BEFORE THE SOUTH DAKOTA PUBLIC UTILITIES COMMISSION

DOCKET NO. EL19-027

**IN THE MATTER OF THE APPLICATION BY CROWNED RIDGE WIND II, LLC FOR
A PERMIT OF A WIND ENERGY FACILITY IN DEUEL, GRANT AND CODINGTON
COUNTIES**

DIRECT TESTIMONY OF DARREN KEARNEY
ON BEHALF OF THE PUBLIC UTILITIES COMMISSION STAFF
December 6, 2019

Crowned Ridge II Wind Farm

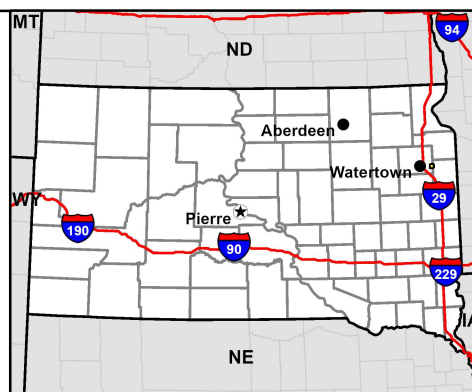
23 With the GIS shapefiles I had access to, the only turbine that raised a concern for me
24 was CRII-64. It caught my attention because the shapefile I used for the city limits of
25 Kranzburg showed the turbine was sited closer than 1 mile from the city limit boundary.
26 Based on the city limit shapefile I used, the proposed turbine is 5,219 feet from the city
27 limit located in the NW $\frac{1}{4}$ of the NE $\frac{1}{4}$ of Section 1, Township 116N, Range 51W. In
28 response to data request 2-18, Crowned Ridge II stated the turbine is 5,288 feet from
29 the city limit and provided a map demonstrating such. The Kranzburg city limit shapefile
30 used in the map provided by Crowned Ridge II shows the city limit being further west in
31 the NW $\frac{1}{4}$ of the NE $\frac{1}{4}$ of Section 1, Township 116N, Range 51W than the shapefile I
32 used.

1 I will send Crowned Ridge II a follow-up data request to provide the legal description for
2 the municipal boundary for Kranzburg in order to verify which shapefile is correct. Once
3 the municipal boundary discrepancy is resolved, I will update my testimony at the
4 hearing.
